CITY OF PROVIDENCE, RHODE ISLAND

Department: Providence Water

**RFP Title: WESTERN JOHNSTON HIGH SERVICE EXPANSION (Water Tank) –
CONTRACT 1 (EXP. 12/31/24)**

Addendum #: 2

CONTRACT 1: INTERIOR PIPING TO ONLY INCLUDE INSTALLATION OF TANK RISER PIPE. ALL OTHER INTERIOR PIPING WORK TO BE INCLUDED UNDER CONTRACT 2.

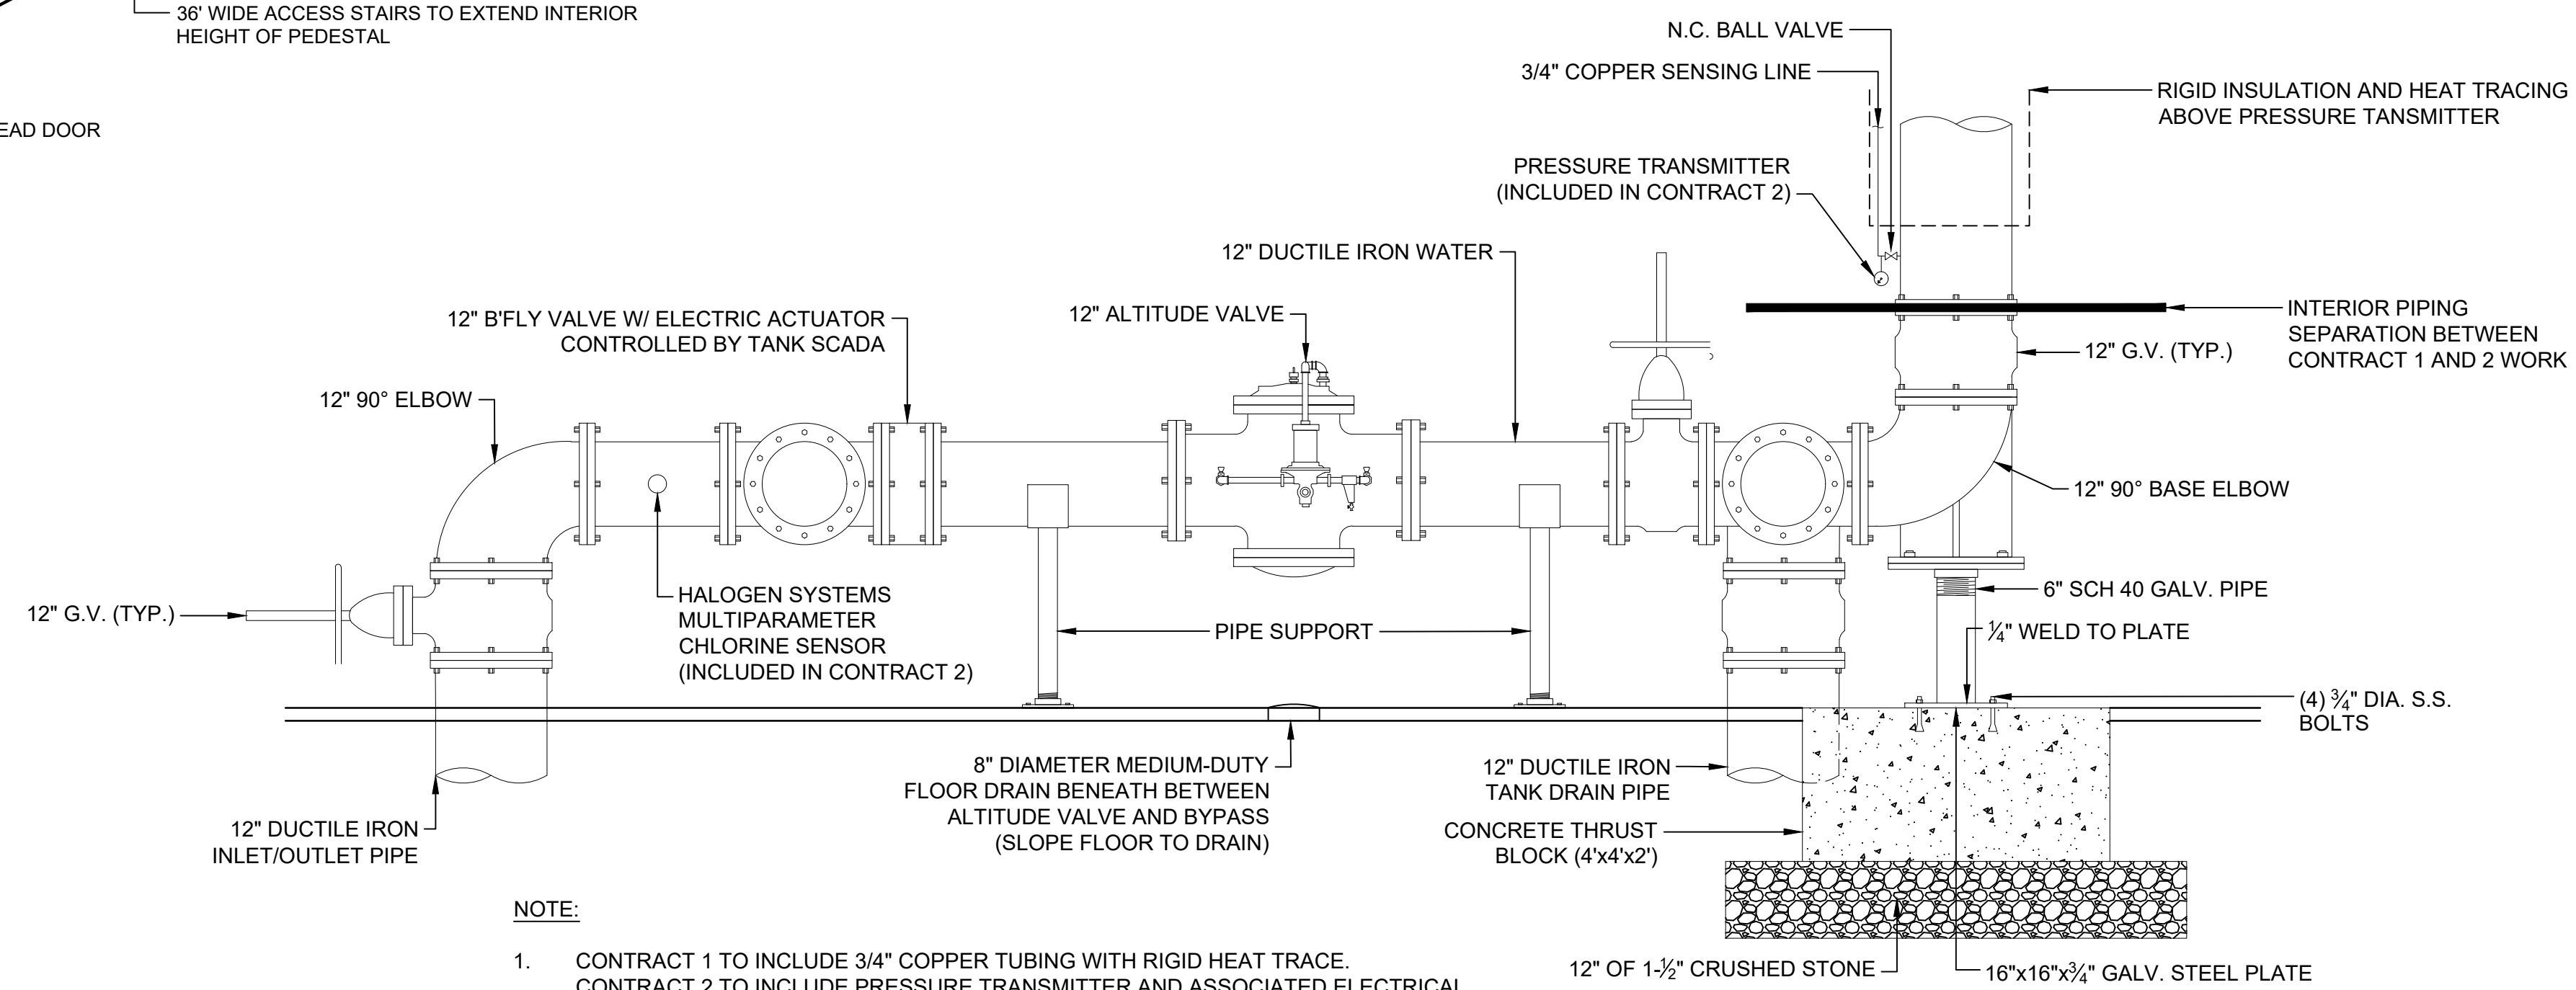
- **SHEET C5.1 – DETAILS 1** (Contract 2 related modifications are italicized)

Replace sheet C5.1 in its entirety with Revised Sheet C5.1 – Details 1 (Addendum No. 3). The revised sheet is attached to this addendum.

1. Replace overhead door callout with “12’ wide overhead door”;
2. *Remove pH and Chlorine Analyzers;*
3. *Remove Chlorine Analyzer Waste Drain Detail;*
4. *Remove “P” Trap Detail;*
5. *Remove Process Flow Schematic – pH & Chlorine Analyzer Detail; and*
6. *Add multiparameter chlorine sensor along interior piping with the following callout “Halogen Systems Multiparameter Chlorine Sensor w/ removal system, wet tap model: WT-01. Sensor shall be integrated with proposed RTU (included in Contract 2)”;* and
7. *Add note to Valve Plan: “Chlorine sensor to be located in a straight length of pipe at least 1.5 times the pipe diameter”.*

- 4. Overhead & Personnel Doors – The elevation view on Drawing C4.0 references a 12’ wide overhead door. The plan view on Drawing C5.1 references a 10’ wide overhead door and two (2) personnel doors. Please confirm overhead door size and quantity of personnel doors (typically 1 at base and 1 at top).**

The overhead door shall have a width of 12-feet. The interior pedestal will have three (3) personnel doors – two (2) at base and one (1) at top.

1. CHLORINE SENSOR TO BE LOCATED IN A STRAIGHT LENGTH OF PIPE AT LEAST 1.5 TIMES THE PIPE DIAMETER.
